ITEM #4: For the ARCHITECTURAL COMMISSION on MONDAY, February 9, 2015 @ 7:00 P.M.

REQUEST: Consideration of modifications to the approved elevations for Building 1 in the Long Grove Commons PUD for the for the “Primrose School” submitted by Mr. John Finnemore

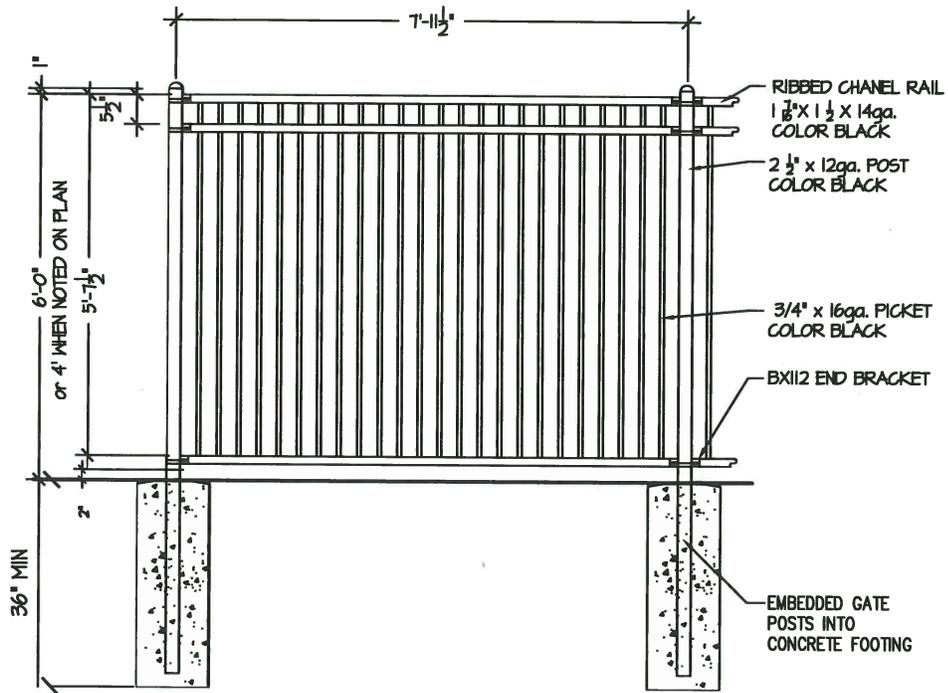
Attached are the approved elevations for Building 1 per the Long Grove Commons PUD approval. As proposed this building was an “L” shaped two story building with false second floor. Materials proposed for the building were hardiboard and stone siding with asphalt shingles.

Proposed elevations for the building are attached. As noted the structure will have a smaller footprint with an occupied second floor. The structure will be placed in the same general location as anticipated in the original approval. Parking is proposed to be reconfigured and has been approved as a minor amendment to the original PUD approval.

Petitioners are proposing a two story structure similar in nature to the PUD approval. Material for the proposed structure include; hardiboard siding, stone and asphalt shingles, similar to those in the original approval. Earthtones are anticipated for the building color scheme. Material samples are anticipated to be presented at the meeting.

① ORNAMENTAL FENCE NTS

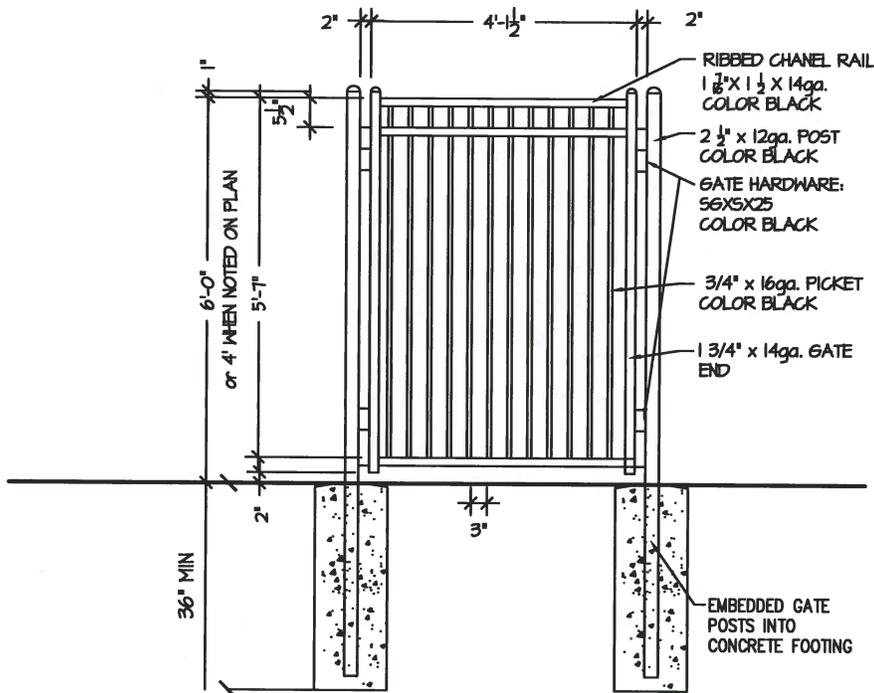
- *Elements of the “Long Grove Style” should be better incorporated into the structure;*
- *More contrast should be added to the color scheme of the building;*
- *Elevations should incorporate more of the architectural details found in the existing structures in Long Grove Commons;*
- *A fencing detail should be provided;*
- *A final landscaping plan should be provided;*
- *Revisions to be presented to the AC at the February 9th meeting (11” x 17” format).*

To that end the petitioner has submitted revised elevations for consideration by the AC which are attached. Fencing detail, a final landscape plan and play ground equipment details are also included for AC consideration.
